Service Bulletin

SUBJECT: **Service Update for Inventory Vehicles Only**

MODELS: 2015 Chevrolet Silverado HD

2015 GMC Sierra HD

3709060

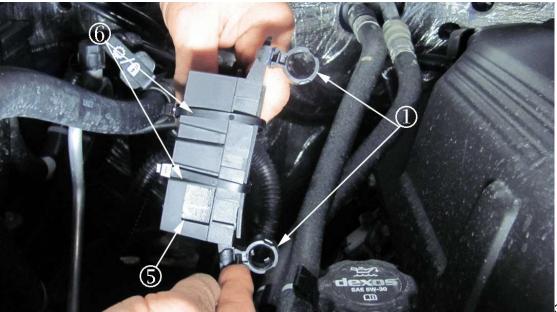
• A fuse block housing assembly that has NOT been reworked will have two brown clips (1) that secure the fuse block housing assembly to the shock tower studs. The fuse block housing cover will also NOT have a black polyolefin side window shield (5) or a black polyolefin bottom shield that is secured to the fuse block housing assembly with two black tie straps. If the fuse block housing assembly rework has NOT been performed, perform the rework procedure in this bulletin. Proceed to step 3.

3709065

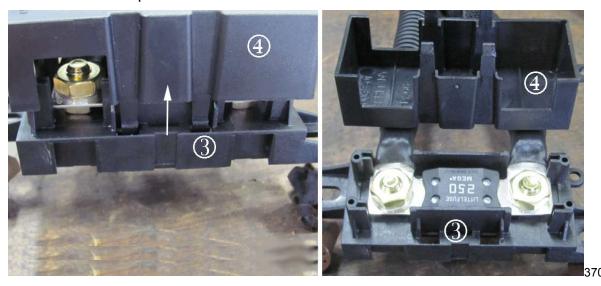
- A reworked fuse block housing assembly will have two black clips (1) that secure the fuse block housing assembly to the shock tower studs. The fuse block housing cover will also have a black polyolefin side window shield (5) and the bottom of the fuse block housing will have black polyolefin bottom shield that is secured to the housing assembly with two black tie straps (6). If the rework has been completed, no further action is required.
- 3. Disconnect the negative battery cable. Refer to Battery Negative Cable Disconnection and Connection in SI.

3709042

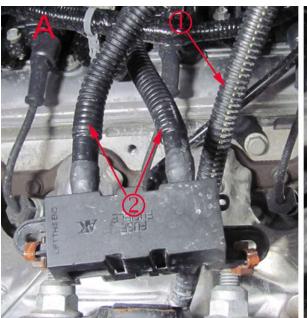
Note: Review the current orientation of the brown clips (1) on the fuse block. Ensure the black clips are installed in the same orientation as the brown clips were installed.

- 4. Remove the brown clips (1) from the fuse block using wire cutters or similar tool.
- 5. Discard the brown clips.
- 6. Install the black clips onto the fuse block.

7. Remove the fuse block housing assembly cover (4) from the base of the fuse block (3). The cover (4) is held secure by four small cleats.

3709077

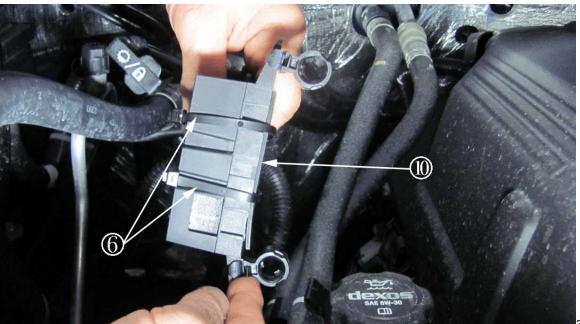
- 9. Insert a 23 x 26 mm (0.90 in x 1 in) black polyolefin shield inside the fuse block cover in the fuse block cover window area (5) as shown in the 'A' portion of the photograph.
- 10. Snap the fuse cover over the fuse block base as shown in the 'B' portion of the photograph. This will wedge the black polyolefin shield into place and close off the side fuse cover window (5).
